Process Sheet

Customer	: CU-DAR001 Dart Helicopters Services	Drawing Name	: SLIDE BAR
Job Number	: 26219		
Estimate Number	: 11085		
P.O. Number	: N/A	Part Number	: D30111
This Issue	: 3/13/2006 S.O. No. : N/A	Drawing Number	: D3011 REV A
Prsht Rev.	: NC	Project Number	: N/A
First Issue	: N/A	Drawing Revision	: A
Previous Run	: N/A	Material	: N/A
Written By	: See COMMENT BELOW	Due Date	: 3/30/2006 Qty: 5 Um: Each
Checked & Approved By	: JF 06.03.13		
Comment	: Est. C 02.06.09 Added D6202 at step 2 NG

RAPPAL SLIDE BAR

From: David Shepherd [davids@dartaero.com]
Sent: April 6, 2006 2:15 PM
To: Chris Provencal
Subject: Re: ncr D3011-1

A	01.03.29	NEW ISSUE
DESIGN	DRAWN BY <i>CP</i>	DART AEROSPACE LTD. HAWKSBURY, ONTARIO, CANADA
CHECKED	APPROVED	DRAWING NO. D3011
DATE	01.03.29	REV. A SHEET 1 OF 1 SCALE 1:2

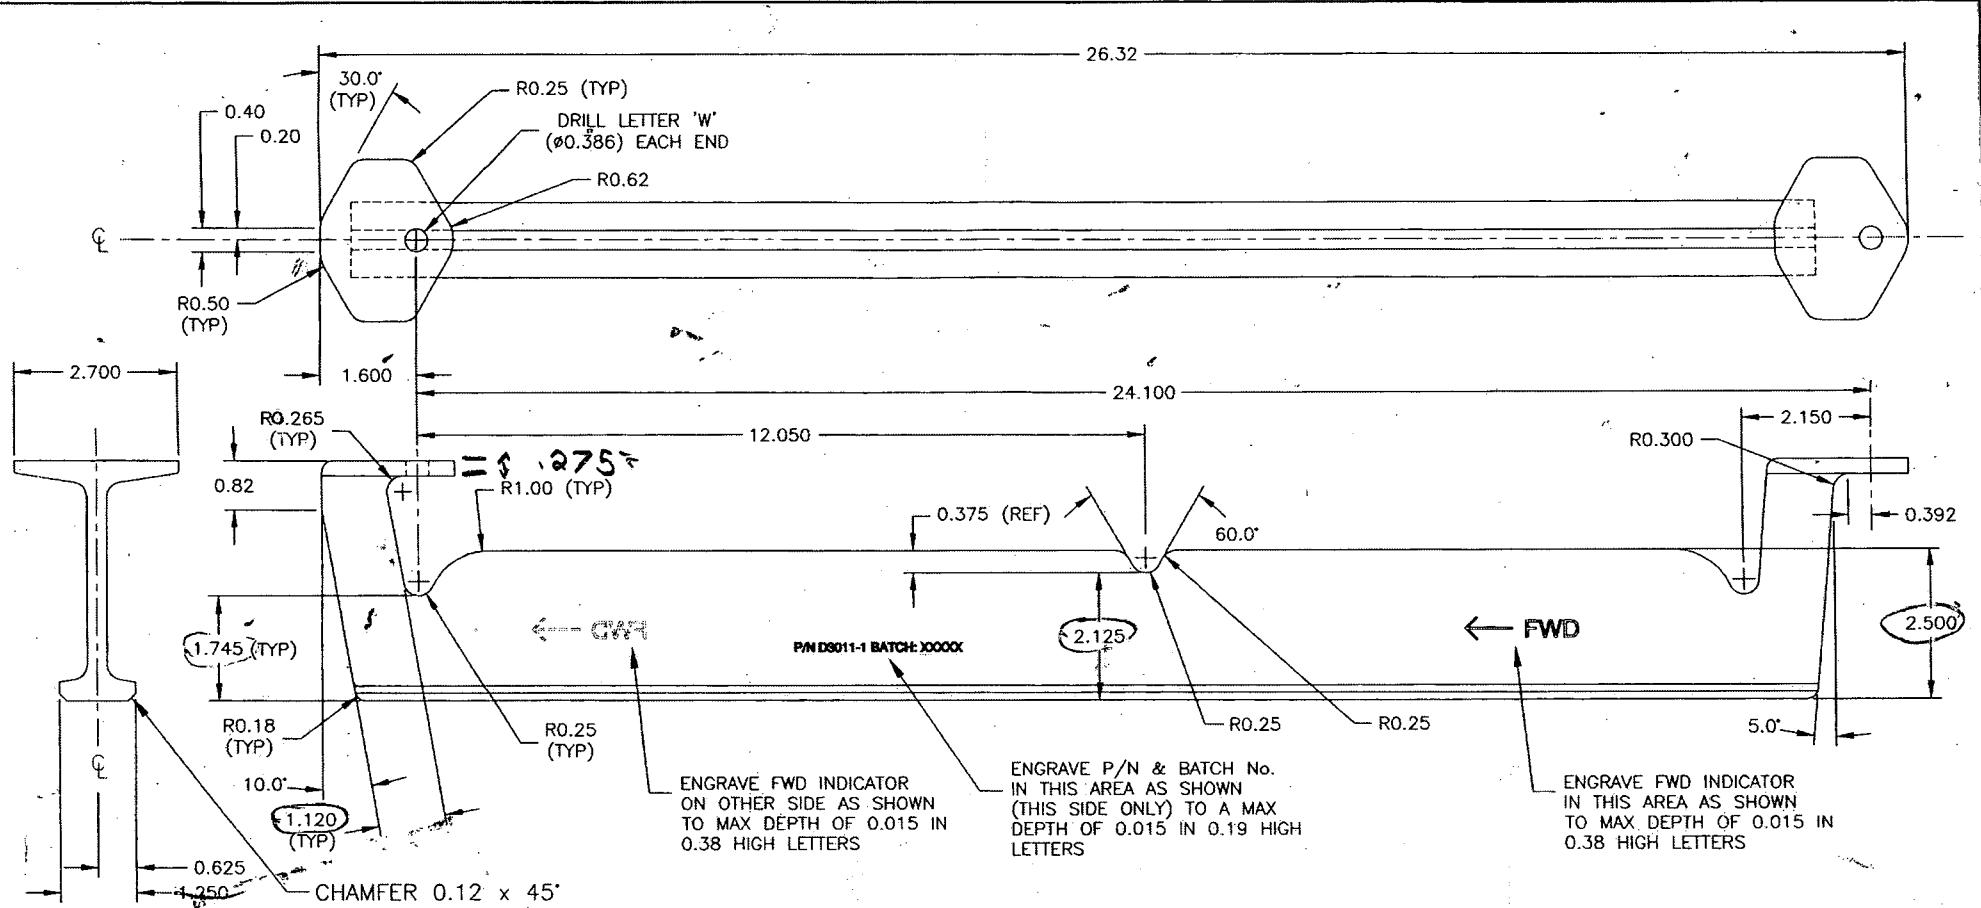
NCR:		WORK ORDER NON-CONFORMANCE (NCR)						
DATE	STEP	Description of NC Section A	Corrective Action Section B			Verification Section C	Approval Chief Eng	Approval QC Inspector
			Initial Chief Eng	Action Description Chief Eng	Sign & Date			
06/04/05	3	Not the good batch# Batch wasn't changed in program and ran previous B# (B17087)	 <u>QSI-12</u>	Check the batch number in the program before machining the piece. Type new B# Scrap, destroy & replace.	J-F 06/04/05 06.04.05		 QSI-12	 06.04.05
06.04.06	3	Dimension 2.125 is 2.097 Dim 2.500 is 2.465 see attached email and diagrams	 06.04.06 per QSI-042	PART IS OK PER ATTACHED ANALYSIS AND EMAIL	J-L 06.04.06 06.04.11		 06.04.06 per QSI-042	 06.04.11

>
> Dave,
>
> The D3011-1 Rappel Slide Bar. The dimension 2.125" on the dwg is 2.097,
and
> the height 2.500" is 2.465" at its minimum. I did a calculation based on
> SUB2-D205-523 Rev. A page 2, and the margin is still positive. I will fax
> you that calculation, which I did on the photocopied page 2 of the
> aforementioned document.
>
> Is this acceptable?
>
> Sincerely,
> Chris Provencal
> DART Aerospace Ltd.
> Email...cprovencal@dartaero.com
> Phone...613-632-3336
> Fax.....613-632-4443
>
>

I have reviewed the analysis you sent by fax and I agree that the parts mentioned below are an acceptable deviation. Please attach a copy of the analysis and this email to the work order.

5.0 D3011-1 SLIDE BAR ANALYSIS

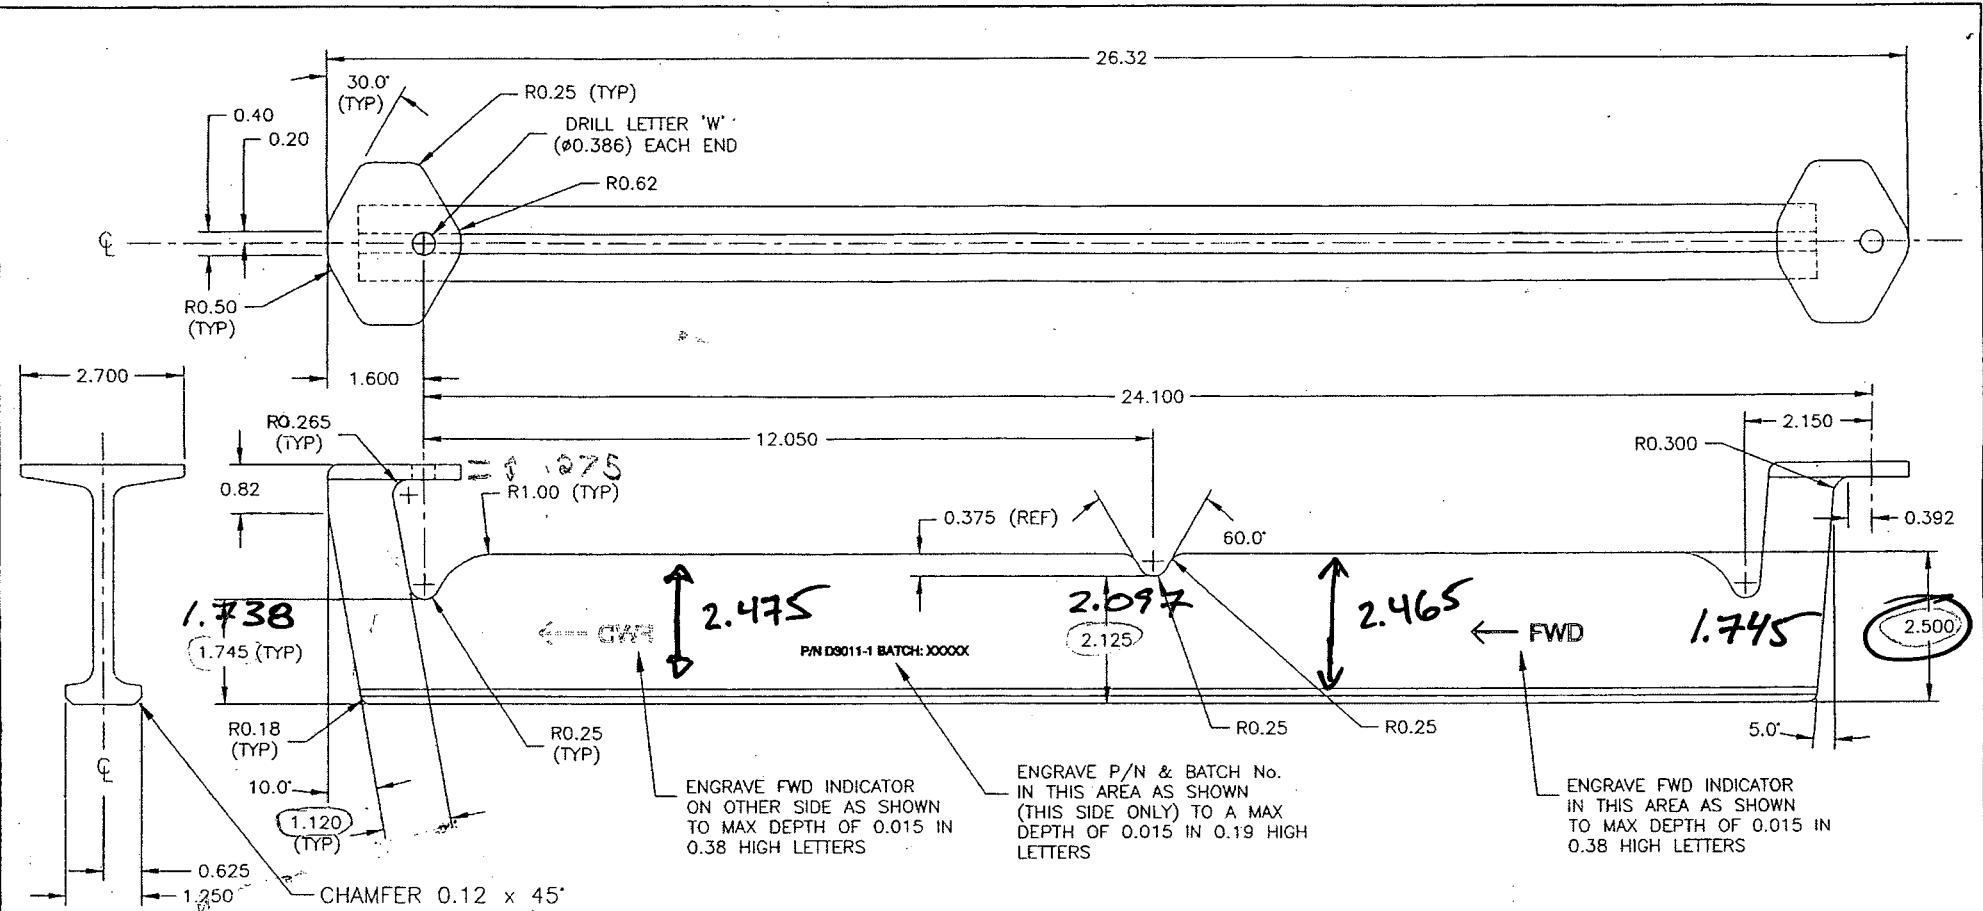
IN COMPARISON TO THE D1005 SLIDE BAR, THE D3011-1 SLIDE BAR HAS AN INCREASED SECTION TO HANDLE A 500 LB WORKING LOAD AT POINT B.

$$\sigma_{cr} = \frac{Mc}{I} = \frac{(11297 \text{ lb-in})(1.33'')}{0.42 \text{ in}^4} = 35.8 \text{ ksi} \quad T = \frac{11297 \cdot 1.33}{0.416}$$

$$MS = \frac{F_{tu}}{\sigma_{cr}} - 1 = \frac{38 \text{ ksi}}{35.8 \text{ ksi}} - 1 = \underline{0.06} \leftarrow \text{OK} \quad = 36118$$

$$MS = \frac{38}{36118} - 1 = 0.05$$

OK
